Basin Bridge Project Traffic and Transportation Effects Peer Review

Job No.	Prepared by	Verified by	Approved by	Status	Issue No.	Date
4319	AD/DS/PD	DS/PD	PD	Draft	1	22/11/2013
4319	AD/DS/PD	DS/PD	PD	Final	1	25/11/2013

Figure 2.1 Hania / Ellice Street Intersection Layout

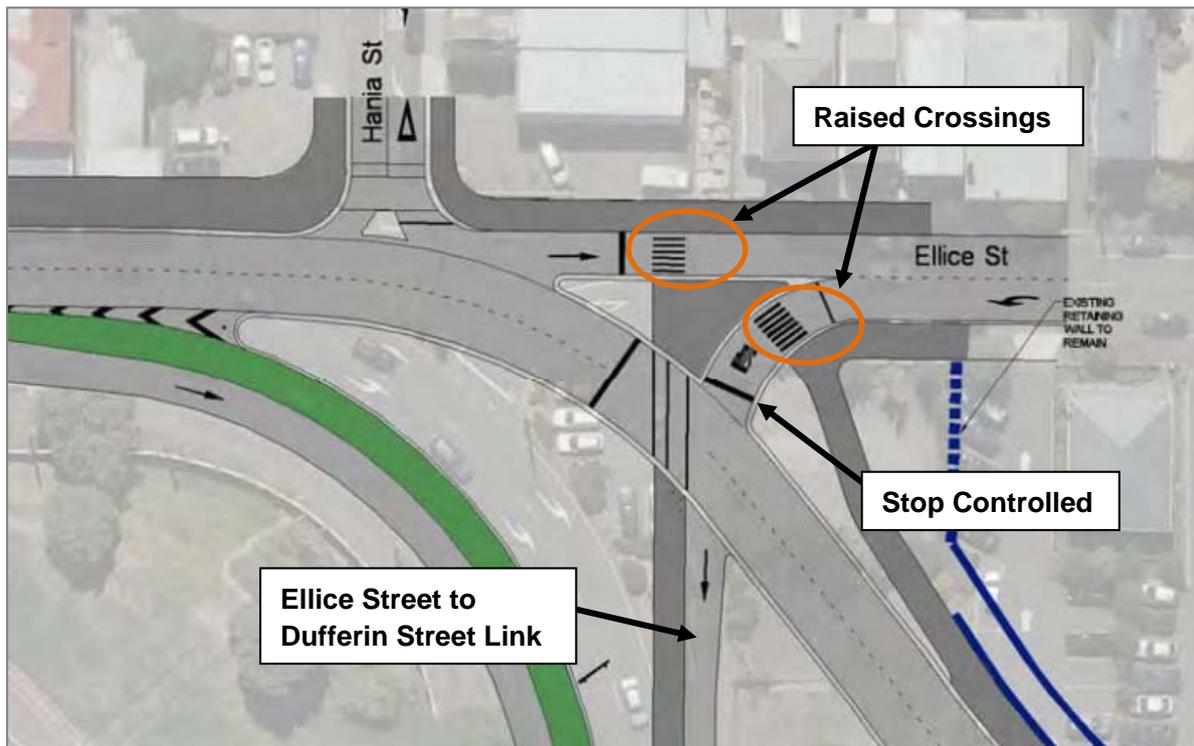
- 2.46 Section 7.1.9 of TR4 indicates that the proposed Ellice Street raised crossings shown in **Figure 2.1** will consist of a raised platform zebra crossing with adjacent drop kerbs implemented for cyclists. The reviewers are concerned that locating a pedestrian and cyclist crossing facility adjacent to each other where in one instance pedestrians have priority over vehicles and cyclists have to give way to vehicles is a complex and confusing arrangement that is likely to result in poor safety outcomes. The reviewers consider this arrangement should be revisited.

18	The location of the drop kerbs adjacent to the raised platform zebra crossing is a complex and confusing arrangement that is likely to resulting poor safety outcomes.	TR4 Section 7.1.9	2.46	May be moderate	Recommend that NZTA provide comment
Safety Assessment					
19	TR4 appears to be contradictory in identifying the type of controls that traffic entering and exiting the Link Road will be subject to, clarification is requested in relation to this.	TR4 Section 7.3.6, 7.8.5	2.48	Moderate	Recommend that NZTA provide comment
20	The reviewers consider the movement of traffic from Ellice Street to the link road should be signalised and operate in conjunction with the pedestrian crosswalk.	TR4 Section 7.3.6, 7.8.5	2.49	Moderate	Recommend that NZTA provide comment

Figure 2.2 Paterson Street / Dufferin Street intersection layout

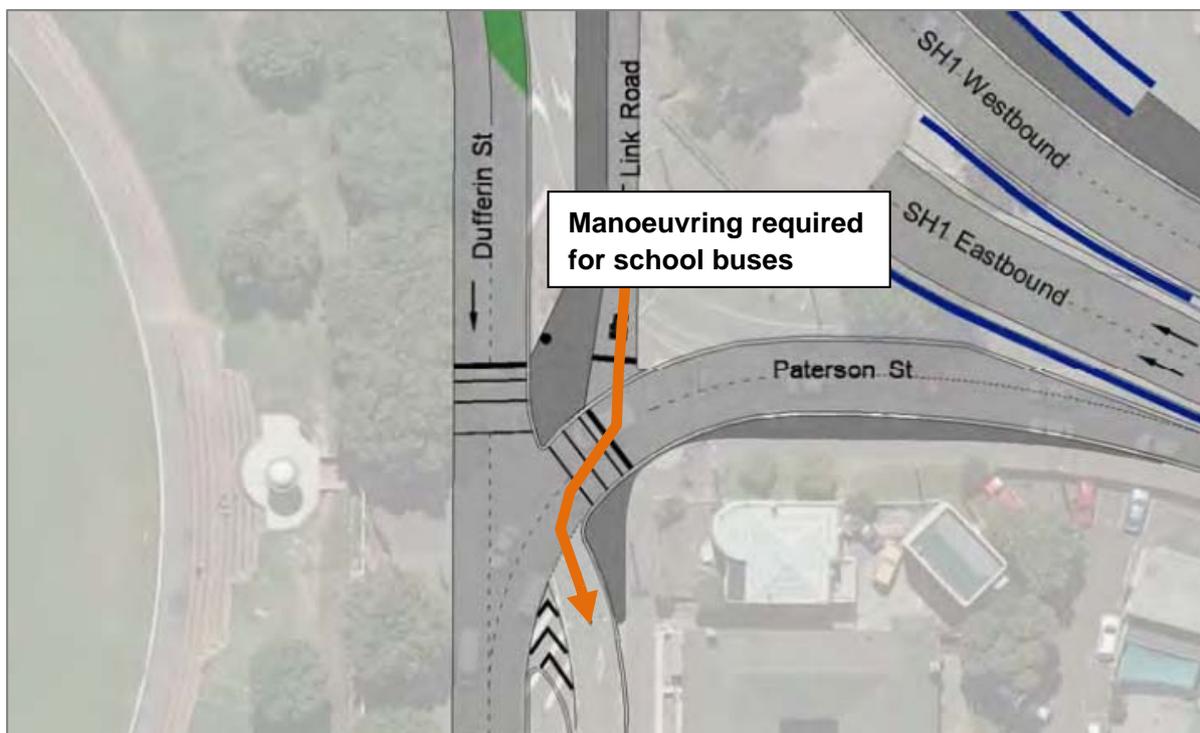
- 2.50 At the Dufferin / Paterson end of the Link Road shown in **Figure 2.2**, traffic has to give way to traffic approaching from Paterson Street. This means traffic exiting the Link Road will be focussed on traffic arriving from the left. Upon identifying a suitable gap it is possible that a driver may move off the limit line and into the intersection without recognising the current phasing of the signals on Patterson Street. Given the proximity of the Link Road to the intersection and in particular the pedestrian crosswalk that provides access to the schools, the reviewers are concerned that this creates a potentially unsafe situation. Again, it is recommended that the Link Road is signalised and incorporated into the operation of the intersection. Alternatively, the Link Road should intersect Paterson Street further from the Dufferin Street intersection.

Item	List of Key Issues	Source Reference	Review Paragraph Reference	Severity	Recommended Action
21	The reviewers consider that the Paterson Street end of the Link Road should be signalised and incorporated into the operation of the intersection, alternatively the Link Road should intersect Paterson Street further from the Dufferin Street intersection.	TR4 Section 7.3.6, 7.8.5	2.50	Moderate	Recommend that NZTA provide comment
Accessibility Assessment					
22	The layout of the school bus pick-up / drop-off area to the south of Rugby Street is significantly less than the current bus parking provision. Further evidence requested to show the number of buses can be accommodated within this area.	TR4 Section 7.8.2	2.51	Minor	Recommend that NZTA provide comment
22	Observation of the s-Paramics model shows that a moderate number of vehicles travelling from Ellice Street will use the Link Road. The report states that the Link Road is not expected to be a preferred route for Mount Victoria residents however further information is requested to support this statement and the physical measures implemented to achieve this. A comparison against alternative routes would be helpful.	TR4 Section 7.8.5	2.52	Minor	Recommend that NZTA provide comment

Figure 2.3 Rugby Street / Adelaide Road intersection layout

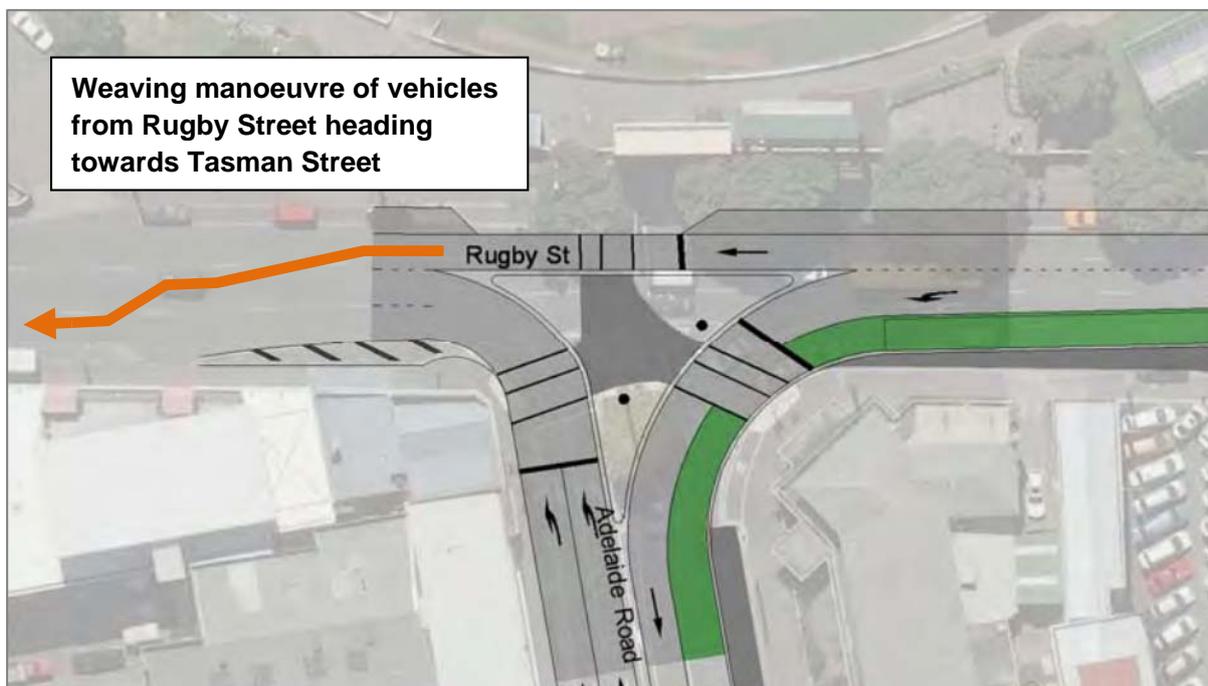
- 2.55 The intersection of Rugby Street and Adelaide Road currently operates with three approach lanes on Rugby Street. However, the project proposes to narrow this down to one lane as shown in **Figure 2.3**. The turning movement survey data reported in Appendix A to TR4 Appendix 4-B, has identified currently between 30 – 65 vehicles per hour travel westbound on Rugby Street past Adelaide Road and exit at the left hand lane of Rugby Street heading toward the Tasman / Rugby intersection.

- 2.56 In order to undertake the same movement with proposed layout shown in Figure 2.3, these vehicles would need to weave across two lanes of traffic over an 80 metre segment. The reviewers are concerned that this is a potentially dangerous weaving situation that may be exacerbated by the two lanes and one lane of traffic from Adelaide Road and Rugby Street respectively being discharged at the same time following the shared pedestrian / cycle phase.

23	The layout of the Link Road through to the school drop-off pick-up area does not enable school buses to easily manoeuvre across.	TR4 Section 7.3.6, 7.8.5	2.54	Minor	Recommend that NZTA provide comment
24	A potentially dangerous weaving situation is identified where vehicles manoeuvre from the right hand lane of Rugby Street to exit at the left hand lane of Rugby Street heading toward the Tasman / Rugby Street intersection. This may be exacerbated by the traffic from the Adelaide Road / Rugby Street intersection being discharged at the same time following the shared pedestrian / cycle phase.	TR4 Section 7.3.6	2.56	Significant	Recommend that NZTA provide comment

Figure 3.1 Route 1 Westbound AM Peak Cumulative Travel Time (from Appendix 4-B)

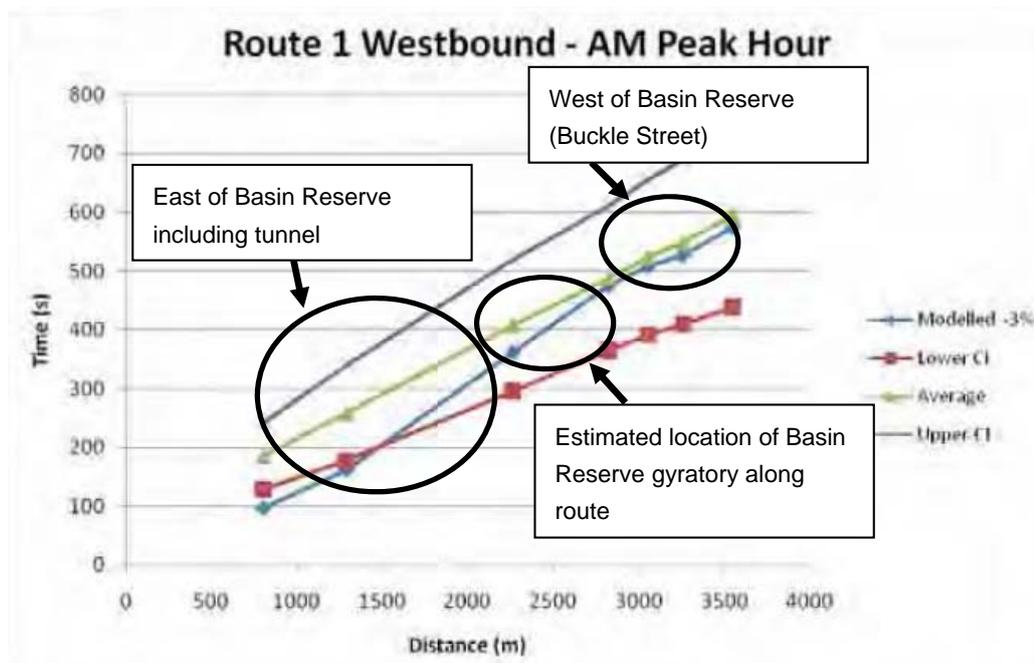
- 3.45 The Route 1 westbound corridor from Evans Bay Parade to Willis Street circumnavigates the Basin Reserve approximately 2.2 - 2.8km along the route. It is evident from the Appendix B route 1 westbound plot in Appendix 4-B (presented here as **Figure 3.1**) that the slope of the average surveyed and modelled cumulative travel time at this location is very different. This is the section over which journey time benefits are realised, therefore it is critical that modelled times closely match surveyed journey times.

Figure 3.2 Modelled Bus Lane Layout on Courtenay Place

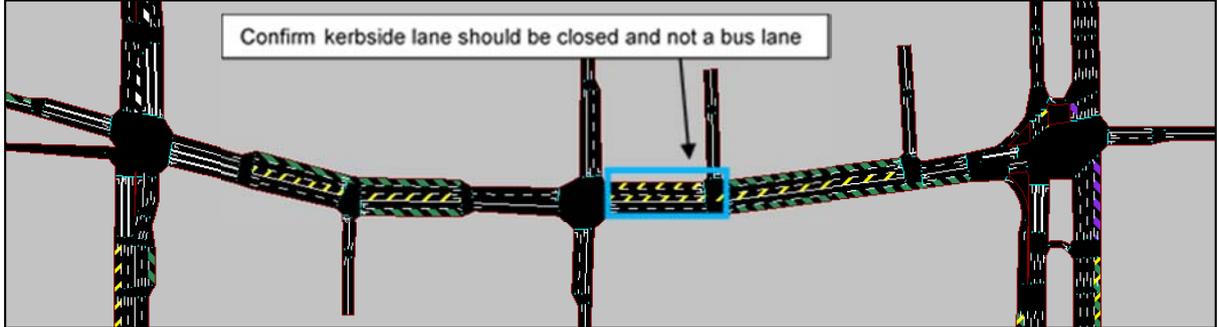
3.68 The bus lanes should be included in both do-minimum and proposed networks, and are intended to operate 24 hours a day on Courtenay Place between Manners Mall and Cambridge Terrace.

3.69 All three period models are consistent in terms of layout and include the correct application of restrictions to limit the lanes for bus use only. The intended layout cannot be confirmed without plans. The kerbside lane in the eastbound direction between Tory and Allen Streets is closed to all vehicles including buses. This is consistent between the do minimum and proposed networks and is likely to have negligible impact on flows in the direct vicinity of the Basin Bridge project.

Item	List of Key Issues	Source Reference	Review Paragraph Reference	Severity	Recommended Action
44	There is no provision for a kerbside bus lane on Courtenay Place in the eastbound direction between Tory and Allen Streets - is this correct?	s-Paramics files	3.69	Minor	Recommend that NZTA provide comment
45	There is provision for a bus lane at the northern end of Cambridge Terrace in the PM peak - is this correct?	s-Paramics files	3.73	Negligible	Recommend that NZTA provide comment
46	Some sections of the Adelaide Rd bus lanes are operating in the interpeak period but are only supposed to be operating in peak periods.	s-Paramics files	3.74-3.77	Minor	Recommend that NZTA provide comment
47	There are additional exit lanes provided on Willis Street exit to SH1/Willis Street/Abel Smith St intersection but these are unlikely to affect the operation of the model.	s-Paramics files	3.82	Negligible	No action required

Figure 3.3 Evening Peak Bus Lane Issue on Cambridge Terrace

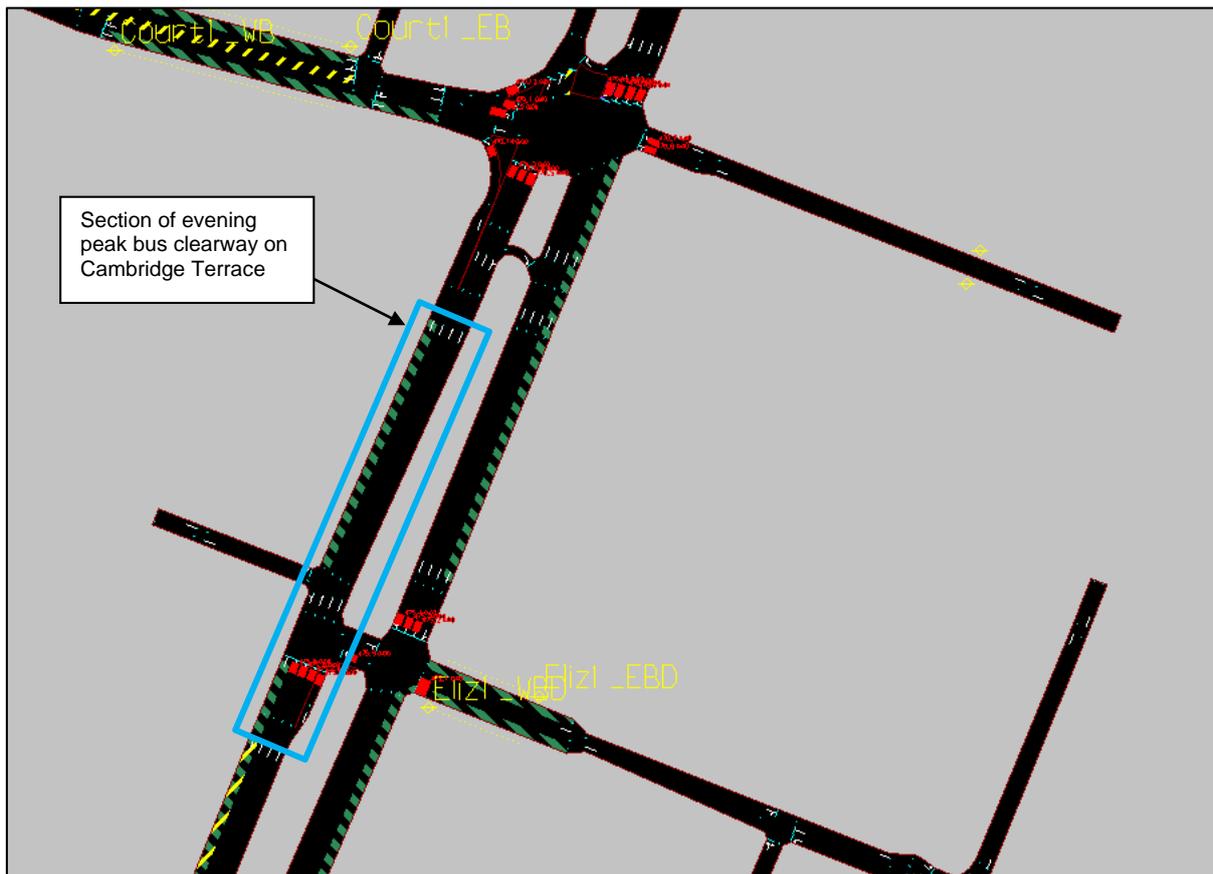
- 3.72 In the evening peak the southbound kerbside lane is coded to allow only buses with all vehicles allowed on the approaches to some intersections. Northbound the clearway is closed to all vehicles apart from the links that allow access to the bus stops.

- 3.73 In the northbound direction in the evening peak the approach to Courtenay Place is coded with a bus-only clearway however without plans it is difficult to ascertain if this section is coded correctly considering this section is closed to all vehicles during the interpeak. This is consistent between the do minimum and proposed networks and is likely to have negligible impact on flows in the direct vicinity of the Basin Bridge project.

Figure 3.4 Interpeak Bus Lane Issue on Adelaide Road

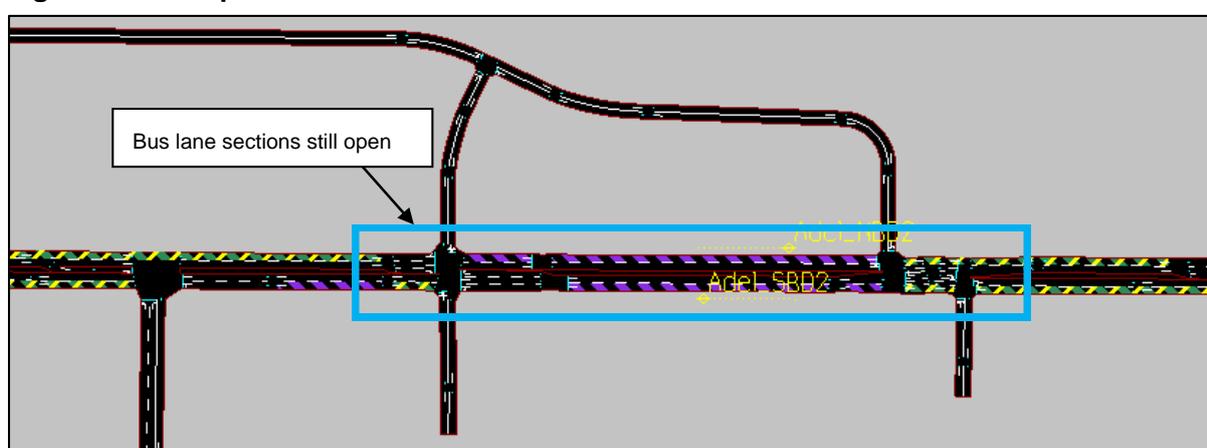
- 3.76 In the interpeak networks, the bus lanes are operating between King Street and Drummond Street. There is also a small section southbound south of Drummond Street with the upstream link closed to all traffic. This allows buses to bypass any queues at the signalised pedestrian crossing north of Drummond Street. If vehicles were parked in the clearway during the interpeak period, buses would be unable to bypass these queues.
- 3.77 Ideally, the links in the network should be split such that the buses can only enter and leave the clearway at the bus stops on these links. Further to this the short section of clearway south of Drummond Street should also be closed to all traffic. This is consistent between the do minimum and proposed networks and is likely to have negligible impact on flows in the direct vicinity of the Basin Bridge project.

Figure 3.5 SH1 / Willis St / Abel Smith St Intersection Comparison

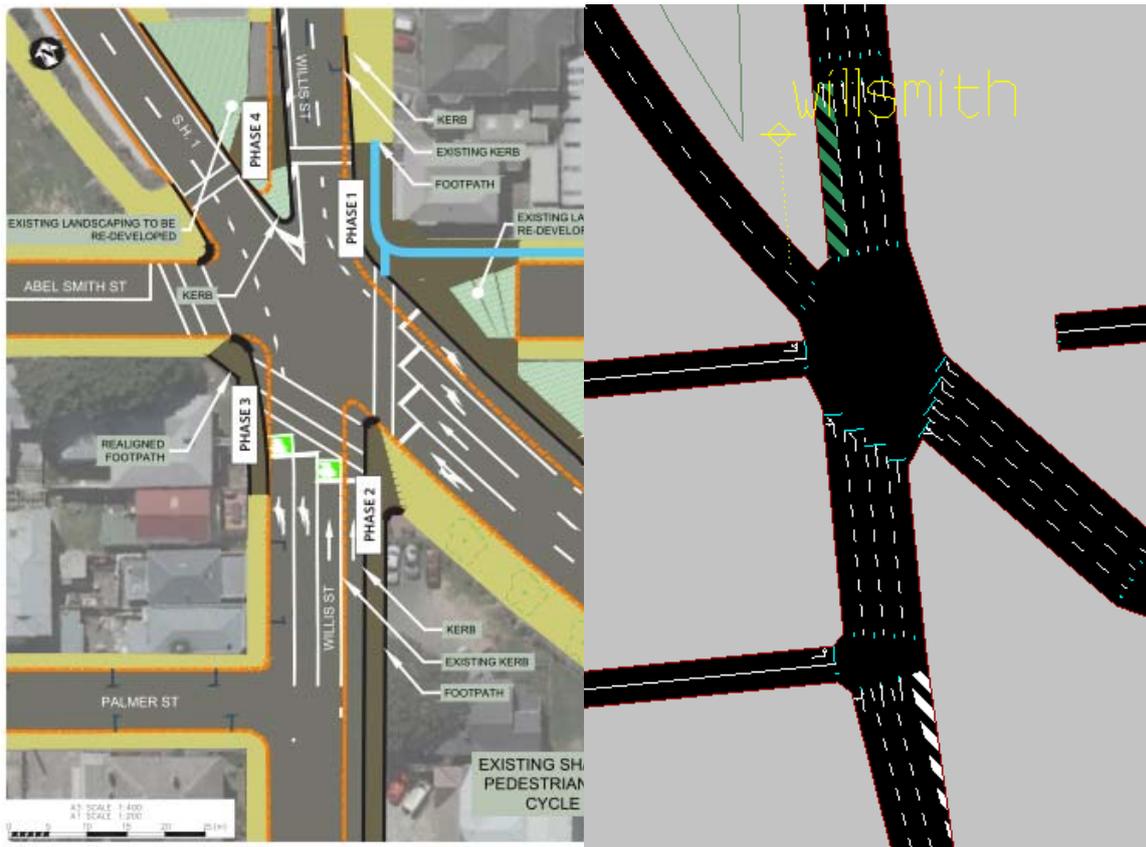
- 3.81 The turning movements at the Arthur Street / Cuba Street intersection have been removed as per the moderate interventions but these appear to still be included in the Buckle Street Underpass road layout drawings on the NZTA website. This is consistent between the do minimum and proposed networks and confirmation is sought over whether this is the appropriate treatment.
- 3.82 There is a minor inconsistency in the number of lanes on Willis Street exiting the Willis / Karo / Abel Smith intersection with four included in the modelled networks and only two proposed as shown in in the ICM improvements. This is consistent between the do minimum and proposed networks and is unlikely to have any noticeable impact on the model operation.
